LAKE TAHOE COMMUNITY COLLEGE
Student Housing Building Project
RFP #22-23-002
Addendum #1

PROJECT: RFP #22-23-002 – Student Housing Building Project

DATE: June 22, 2023

Description(s): Revised Increment 1 Drawings to show:

Drawn By
Author
Checked By
Checker
Project No.
22-100
Date
05/30/2023
Drawing No.
S2.06-2

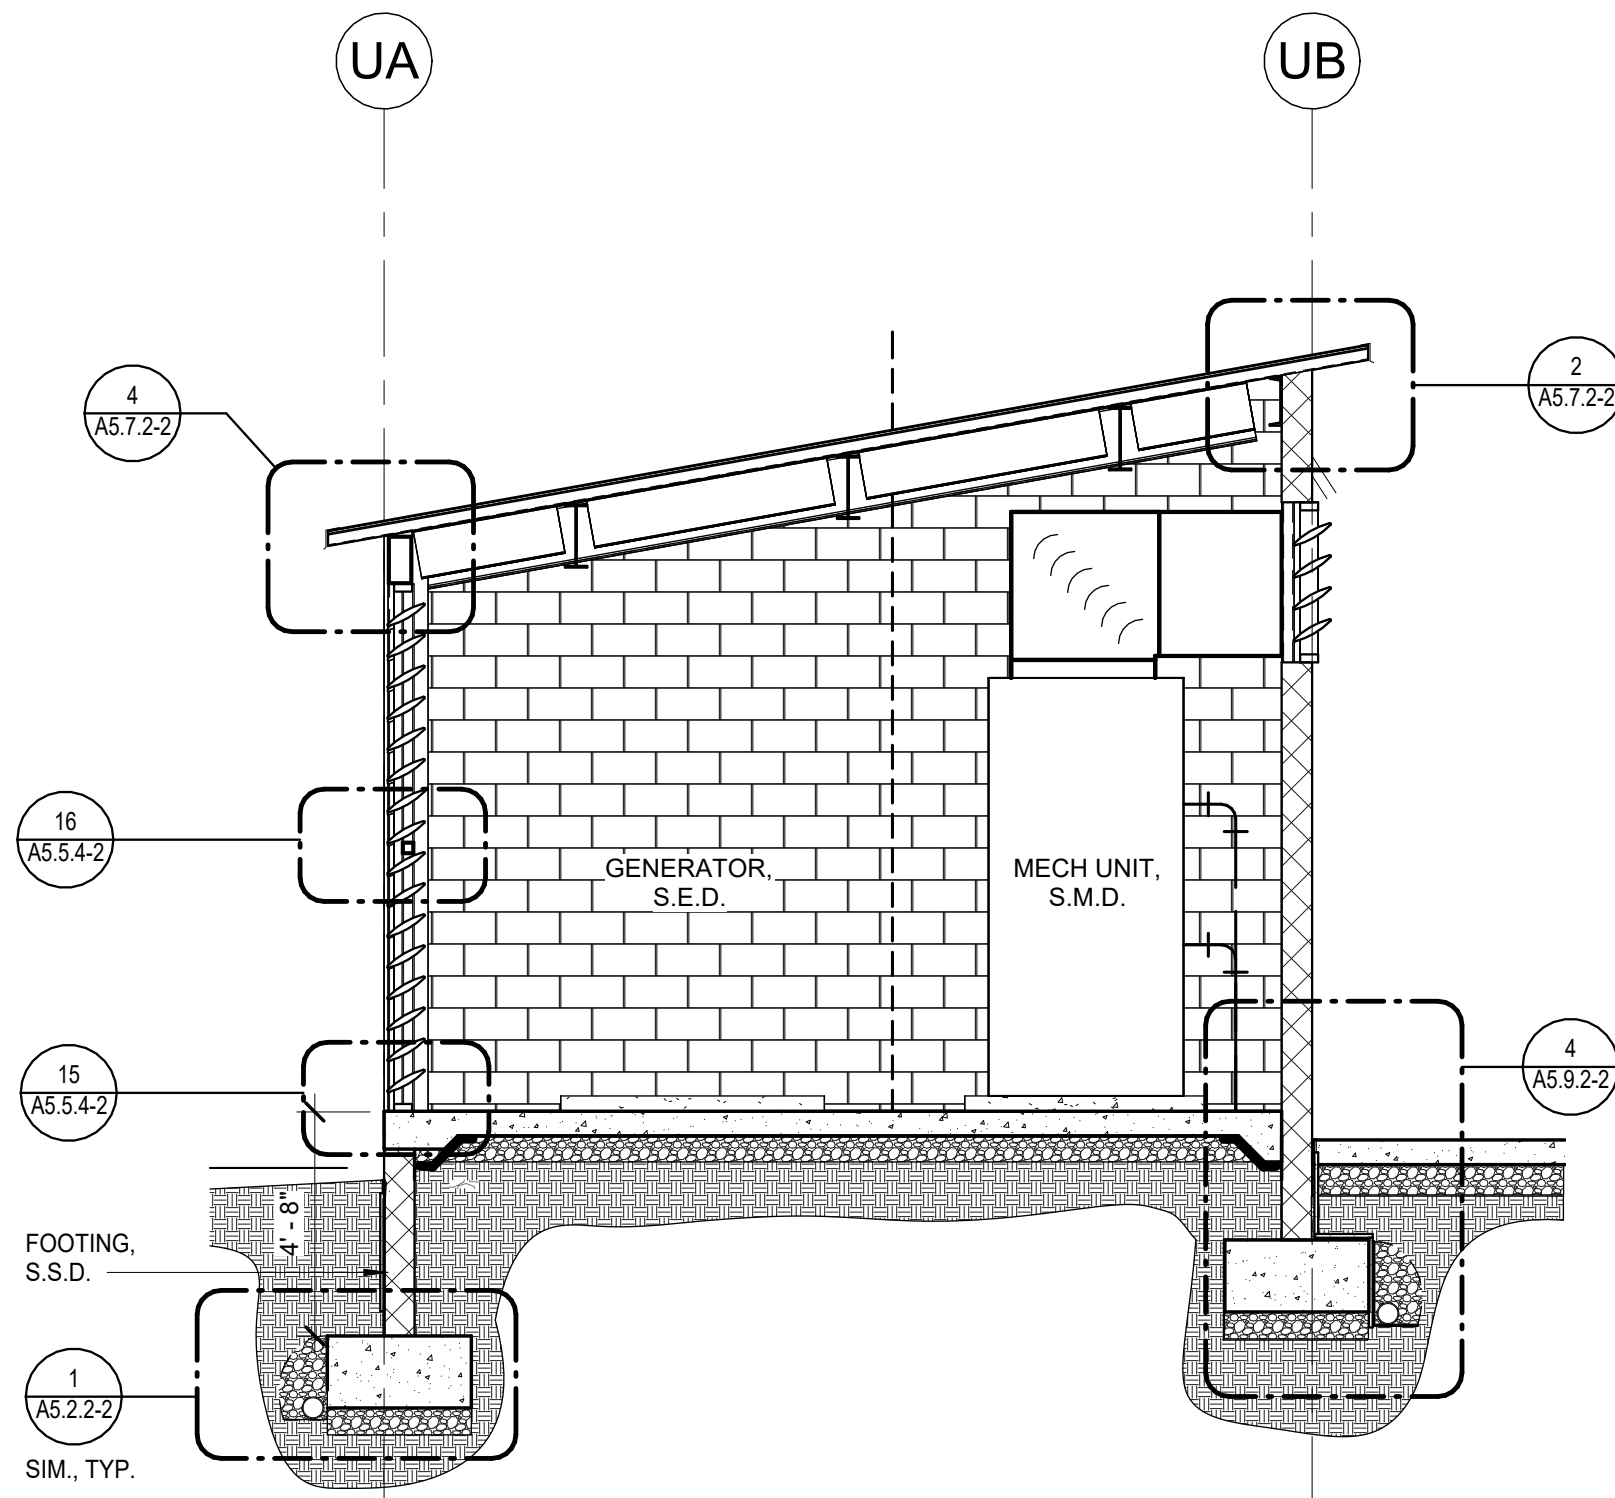
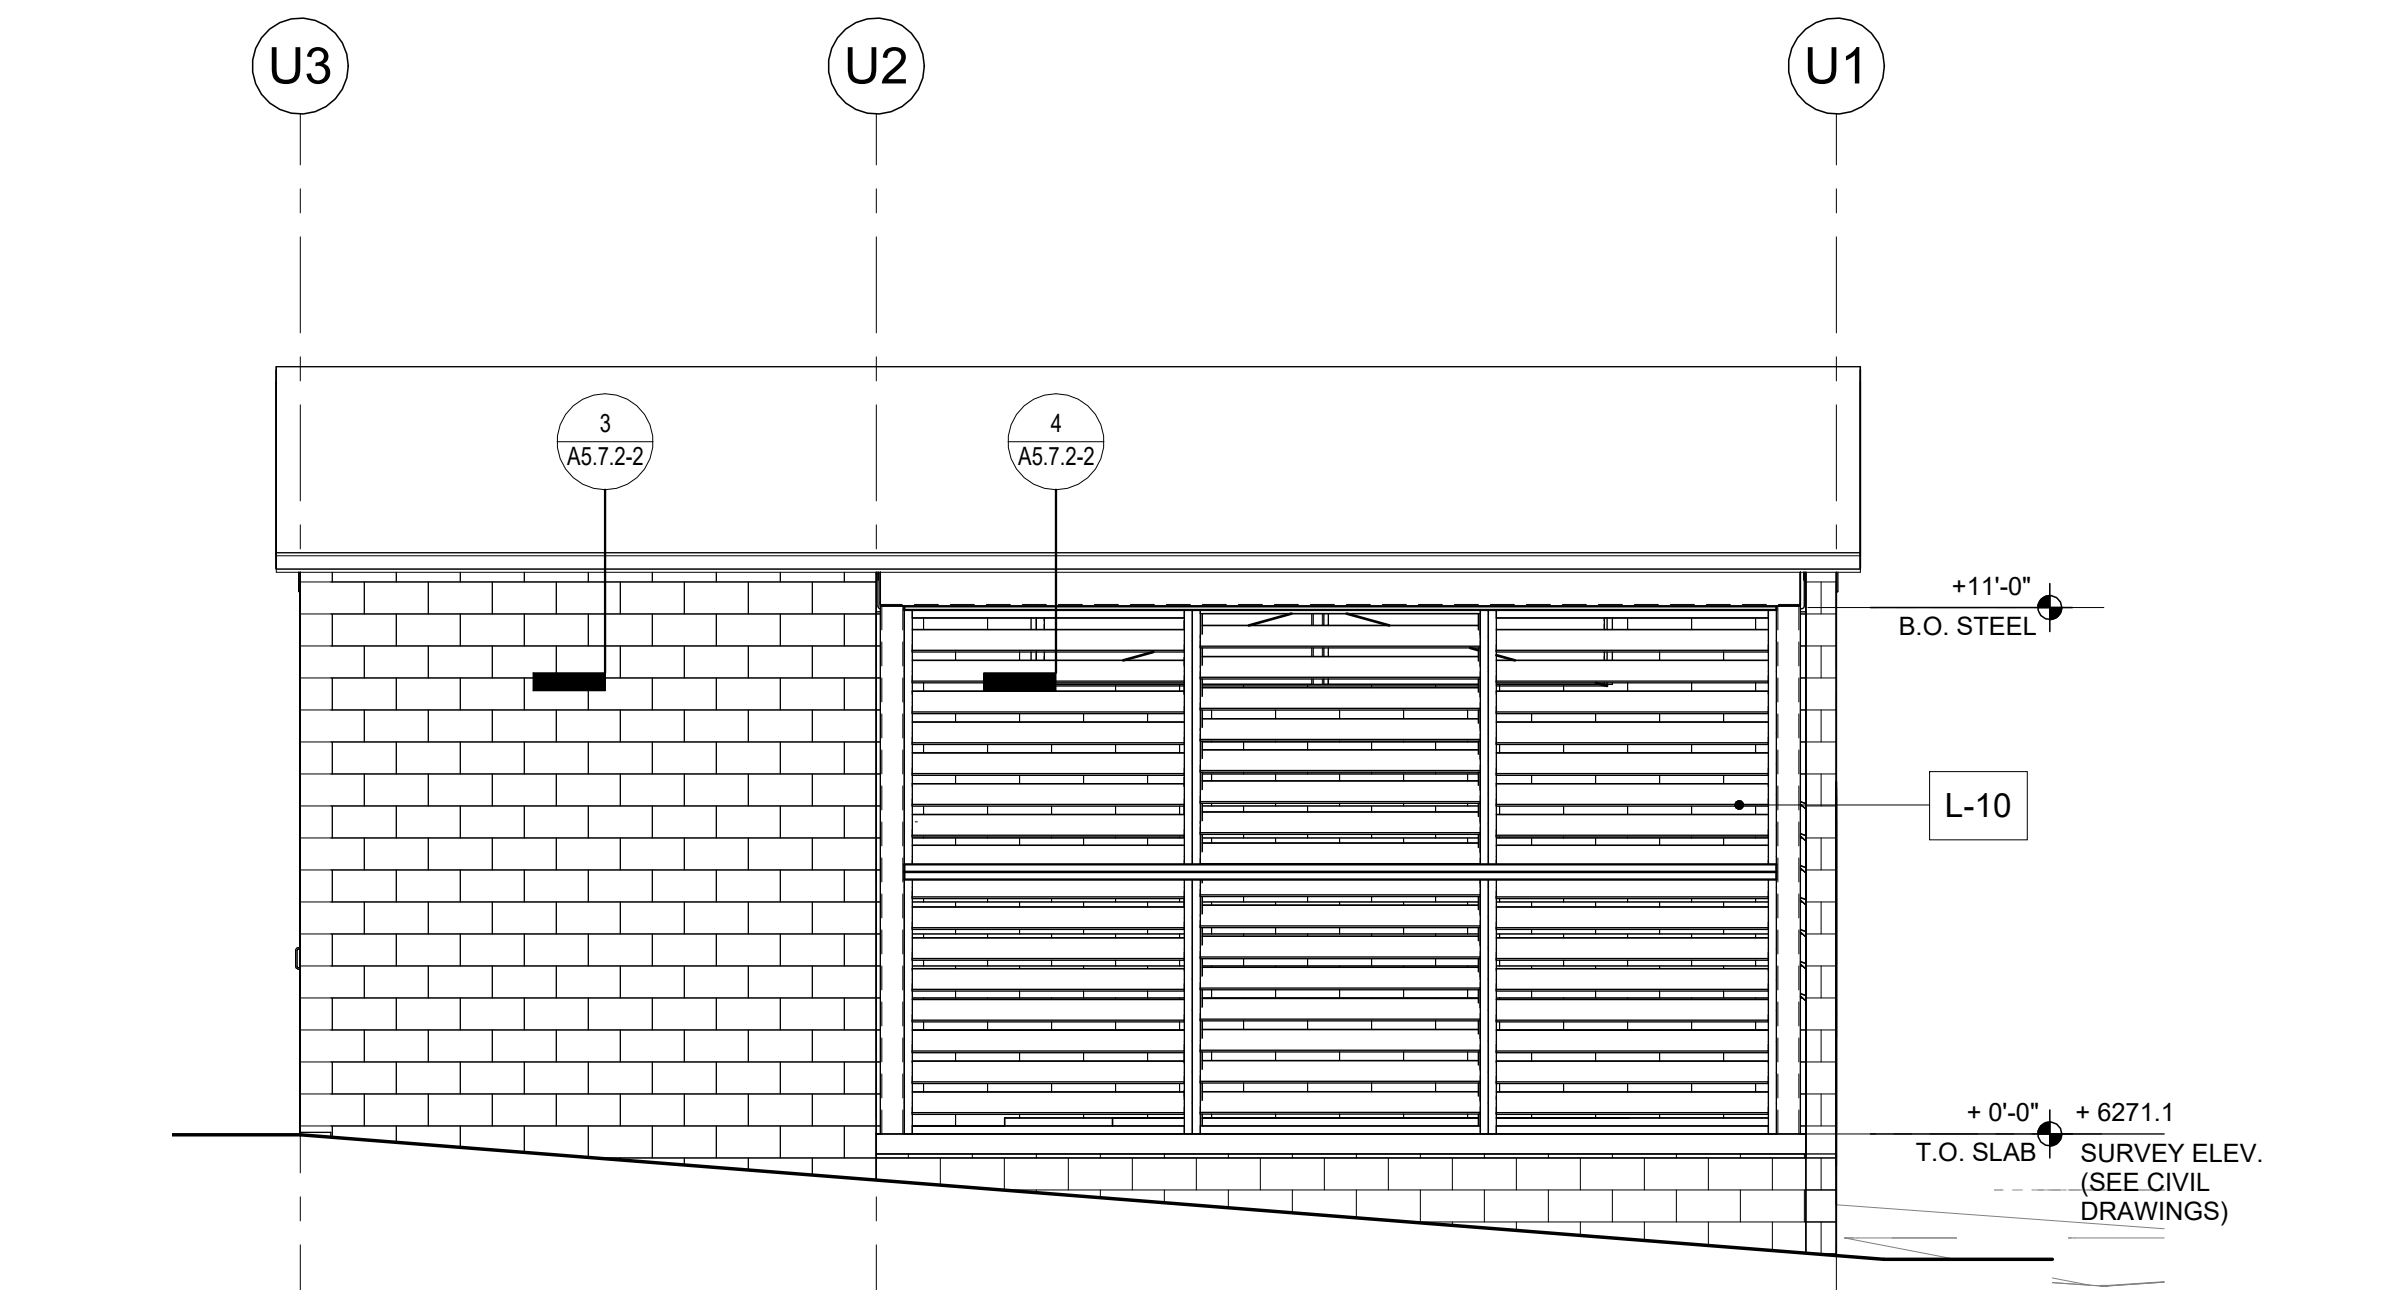
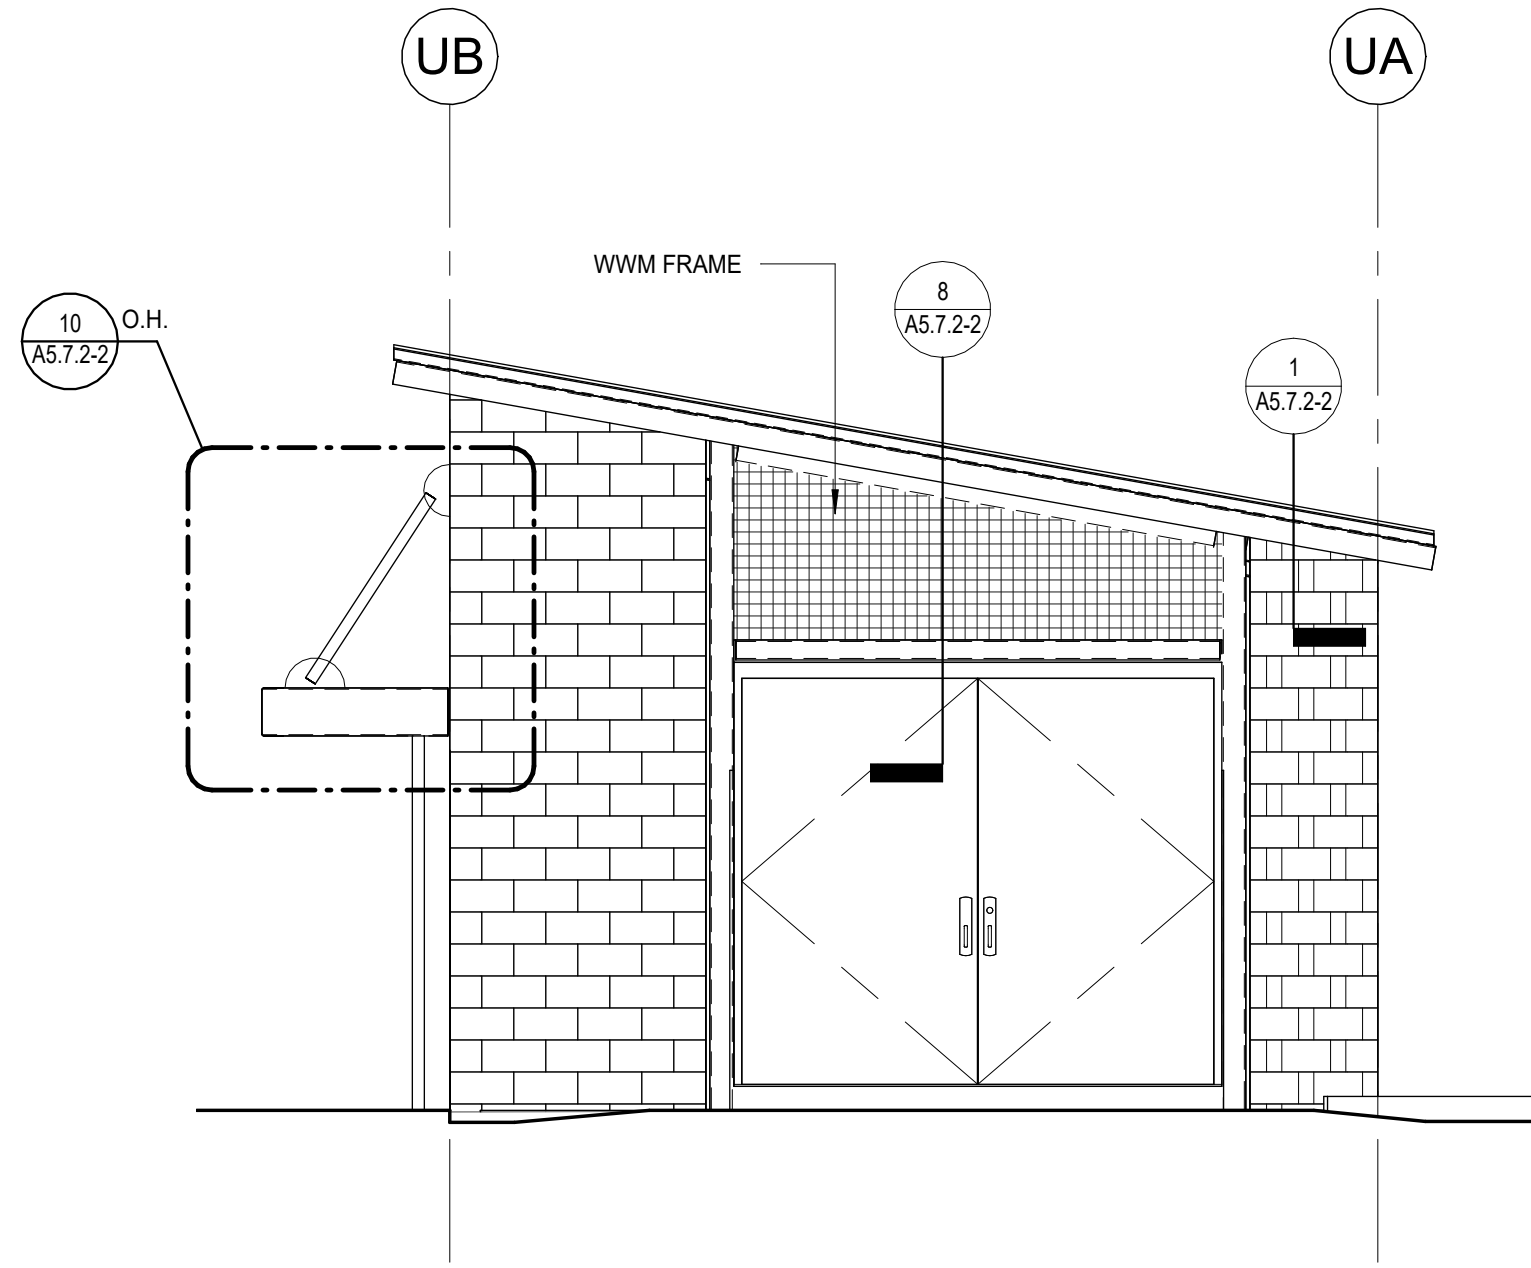
- Removed footing step on Gridline U2.
- Added Electrical Conduit Penetration notes.
- Clarified CMU wall below the gates.
- Adjusted lean mix shown in Elevation 2/S2.06-2.
